EDGERTON PLANNING COMMISSION AGENDA
REGULAR SESSION
Edgerton City Hall
September 12, 2017
7:00 PM

**FINAL SITE PLAN- LOGISTICS PARK KANSAS CITY, PHASE VI, LOT 3, FS
2017-003 (INLAND PORT VII) – tabled from August 8, 2017**

STAFF REPORT

To: Edgerton Planning Commission
Fr: Beth Linn, City Administrator
Re: Application FS2017-06 for Final Development/Site Plan for *Logistics Park Kansas City Phase VI, Lot 3* (Inland Port VII)

Sheet
C09

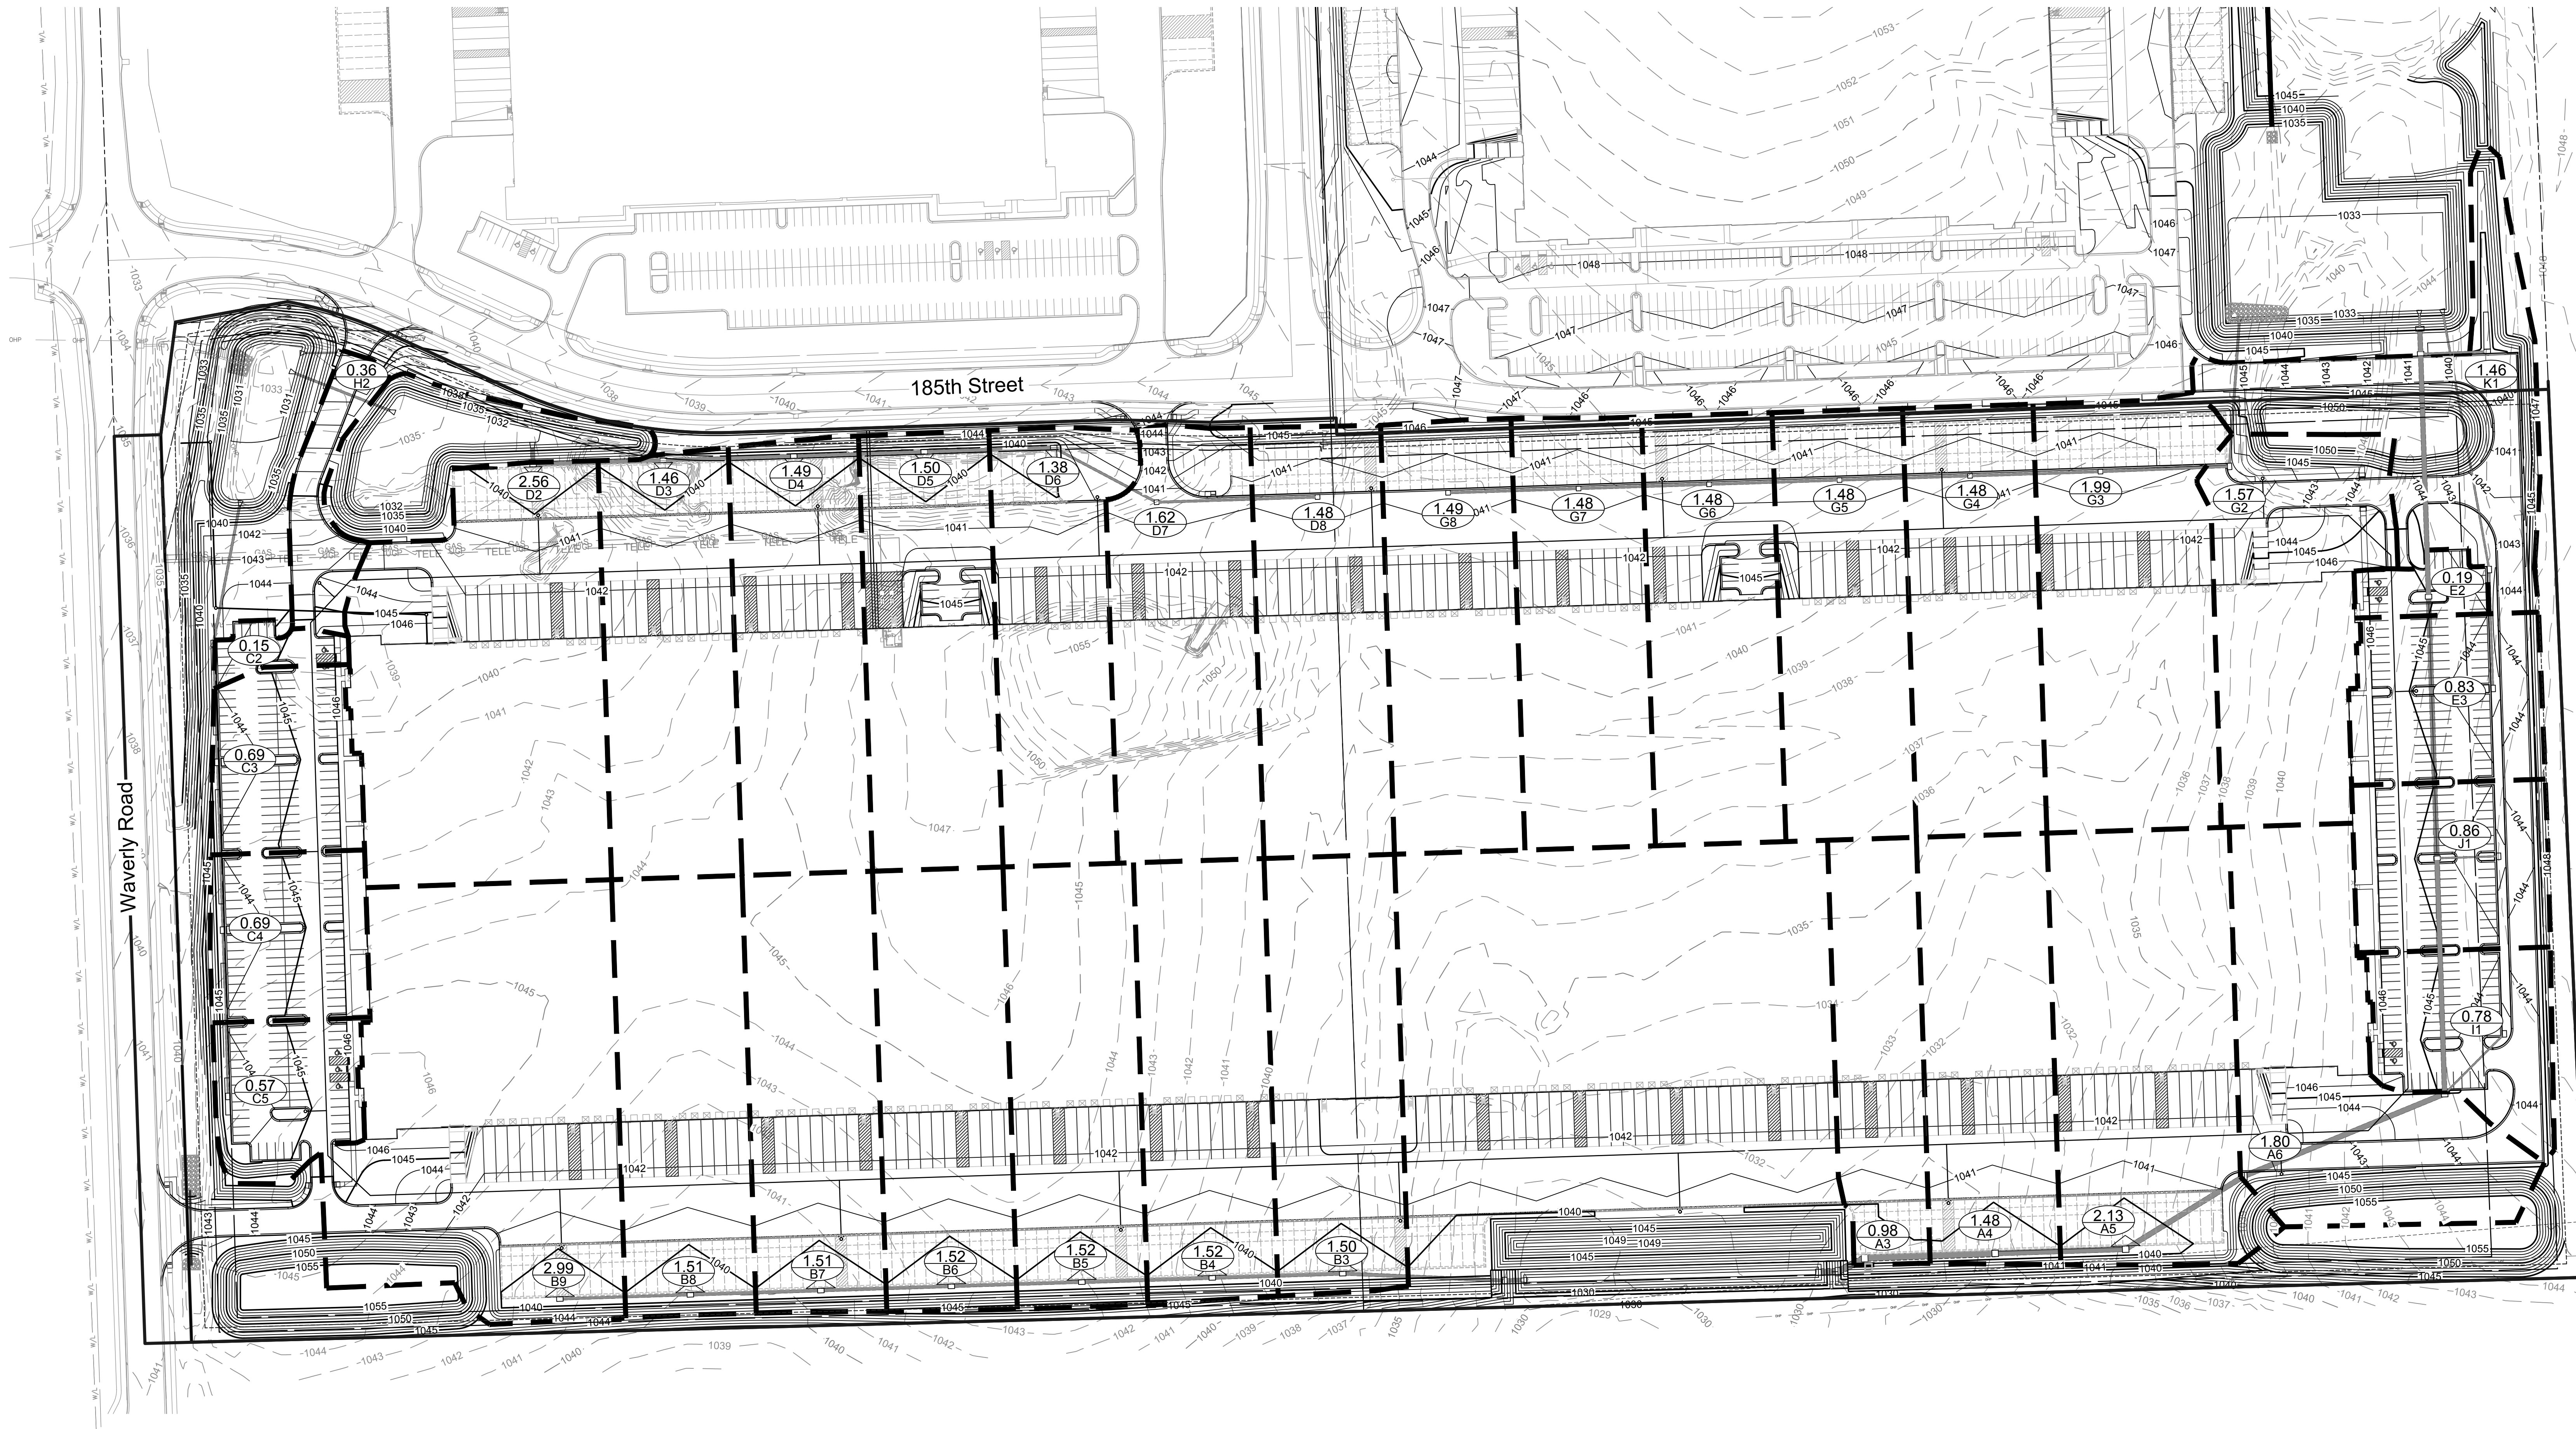
- b) *The majority of the stormwater from this site plus stormwater from a detention basin on adjacent property to the northeast, (IP VI) will be conveyed to a 300' long "level spreader" located along the south property line of this application (IP VII). A smaller amount of stormwater will be conveyed to two detention basins in the northwest corner at Waverly & 185th. **A stormwater should be submitted to the City Engineer prior to approval of building plans.***

1 OVERALL NORTH ELEVATION
Scale: 1/64" = 1'-0"

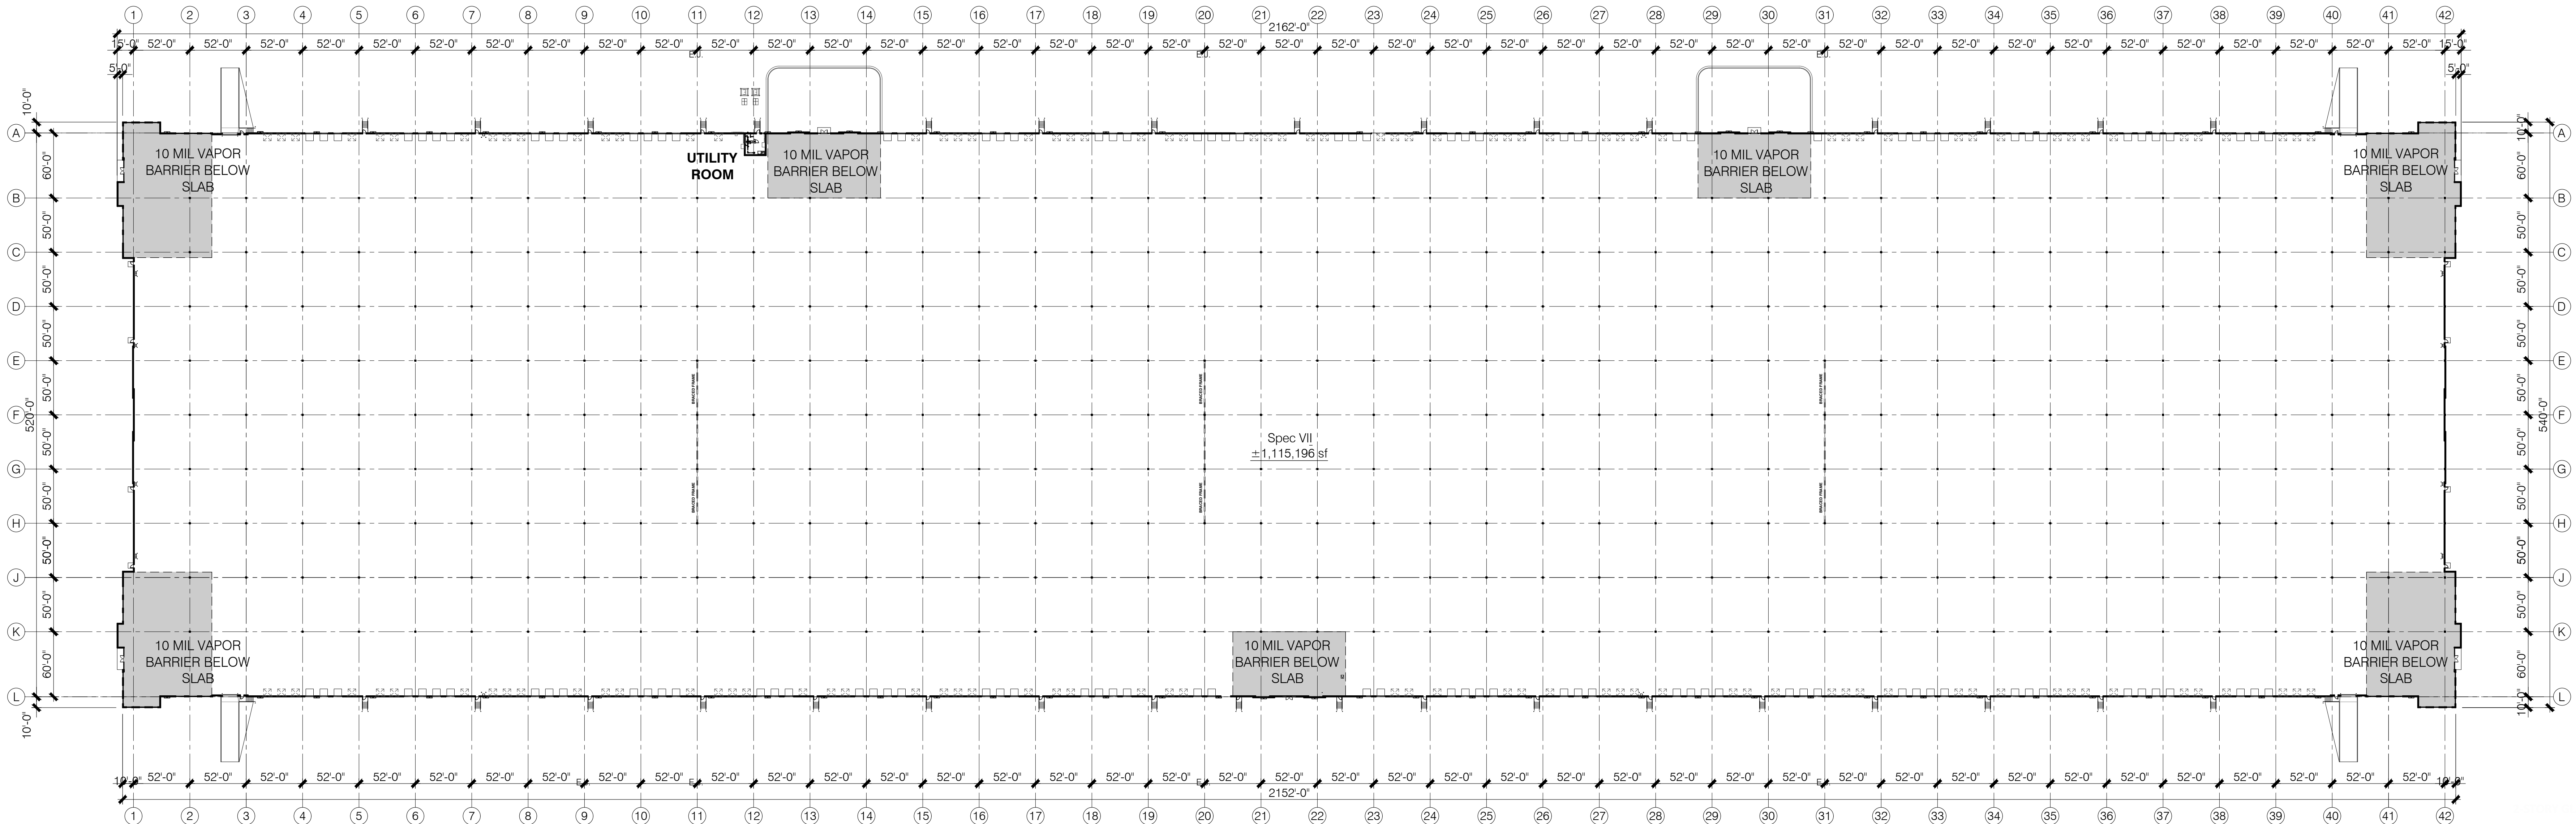
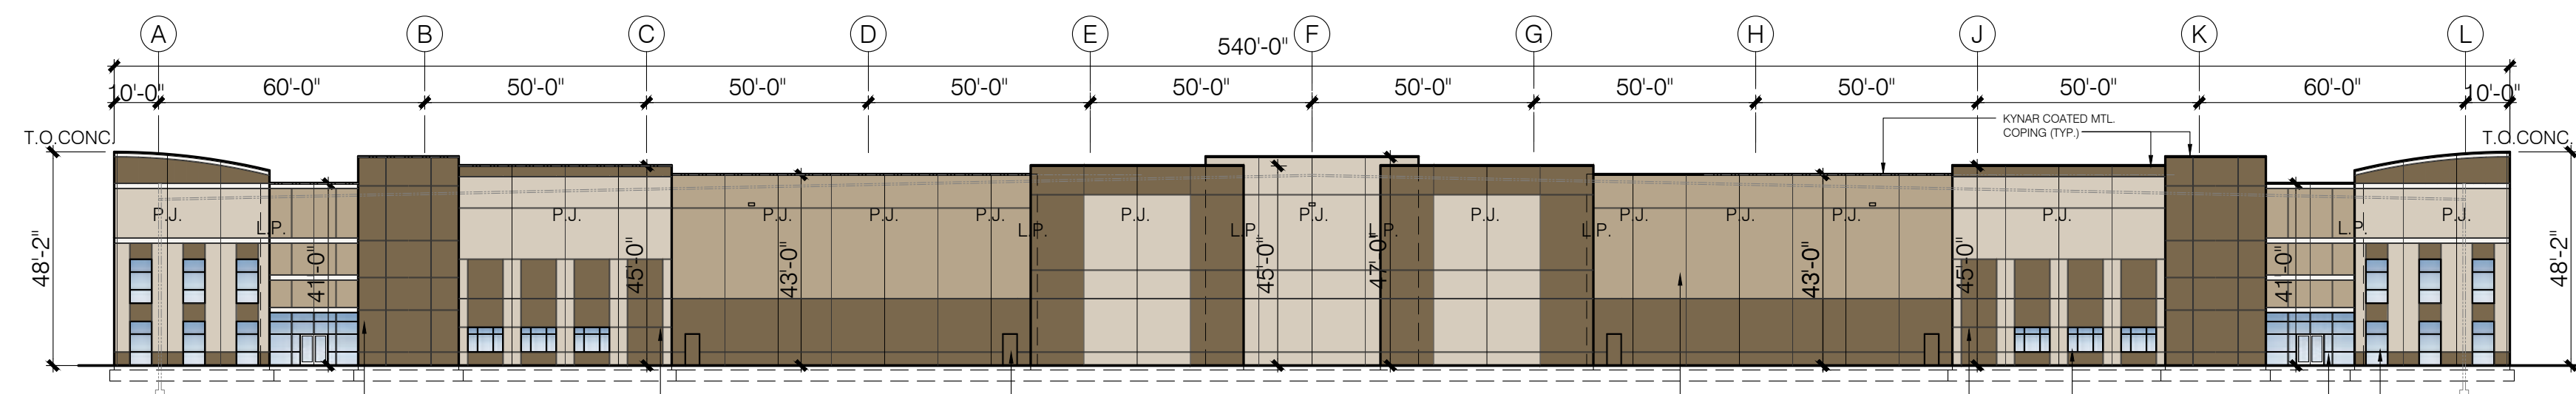
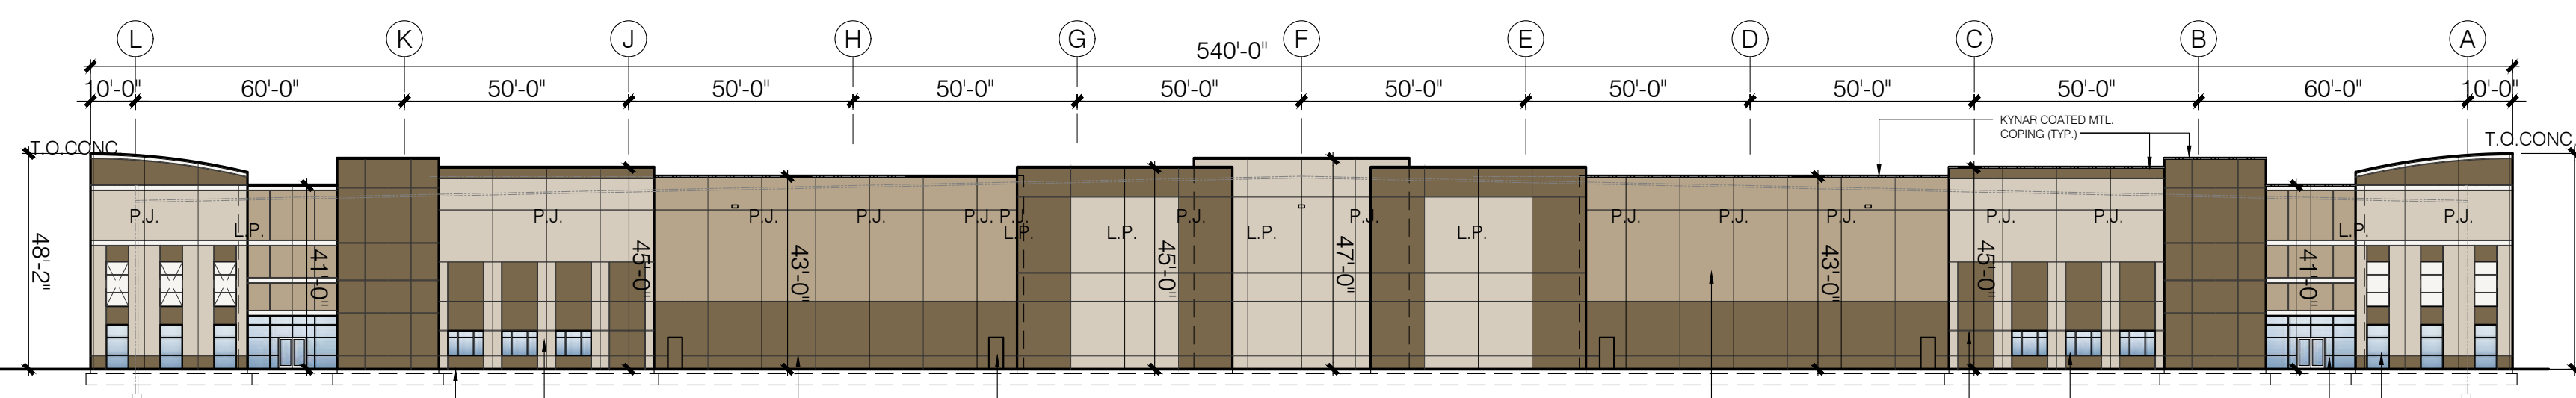
- i. *For both the north and south walls, the height of the walls range between 43'-6" and 48'-2". The maximum length of this wall without additional horizontal articulation is 192'-8". The required horizontal off-sets calculated for this wall is 4.3' & 4.8'. The off-sets provided are 5' & 10', respectively. Meaning the proposed building does not meet the horizontal articulation requirement due to the length of the middle section of this wall. Dock doors on both walls make horizontal articulation nearly impossible to achieve. The applicant has used color blocking to help create visual articulation to meet*

- ii. *Both the east and west walls are 540 long and is off-set 10' at each at each corner of the building. The middle of the east/west façade (wall) measures 270'. The height of the wall ranges between 41'-0" and 48'-2". The maximum length of this wall without additional horizontal articulation is 192'-8". The required horizontal off-sets calculated for this wall is 4.1' & 4.8'. The off-sets provided are 5' and 10'. The proposed building does not meet the horizontal articulation requirement due to the length of the middle section of this wall. The applicant has used color blocking that help create visual articulation. The applicant provided landscaping along both walls in compliance or exceeding the requirements of the code. **If the Planning Commission determines a variance/waiver from this requirement is appropriate, it is recommended they also determine if the screening is adequate to screen street rights-of-way and future residential uses.***

- i. *The minimum height change required is between 4.1 & 4.8 feet. The maximum change in height shown on the south elevation (across the entire length of the building) is 7'-2" feet (41'-0" to 48'-2"). While the articulation between the tops of the lowest and tallest walls exceed this requirement, the overall articulation does not comply as the 10% change in height is required to occur within each 192'-6" foot section of wall. While the elevations do not comply with this requirement more (while smaller) articulation is provided. The applicant has also used color blocking that help create visual articulation. The vertical articulation being provided appears to be the same as that shown on previous projects. **The Planning Commission may decide to approve an exceptions to this requirement based upon the façade elevations that have been provided.***

view with parapets or other architectural design features constructed of the same materials used on the exterior walls. ***Rooftop equipment is not shown on the proposed building elevations. If rooftop equipment visible from the ground and street level is planned, parapets to conceal it from the ground and the streets shall be required prior to building permit approval.***

*the intent of the code. Also the applicant has provided right-of-way landscape buffering at this location for that portion adjacent to public rights-of-ways. This approach is similar to other LPKC buildings in this phase. **If the Planning Commission determines a variance/waiver from this requirement is appropriate, it is recommended they also determine if the right-of-way landscaping buffering proposed will provide adequate screening for that portion of 185th and Montrose Street rights-of-ways exposed to the dock doors.***
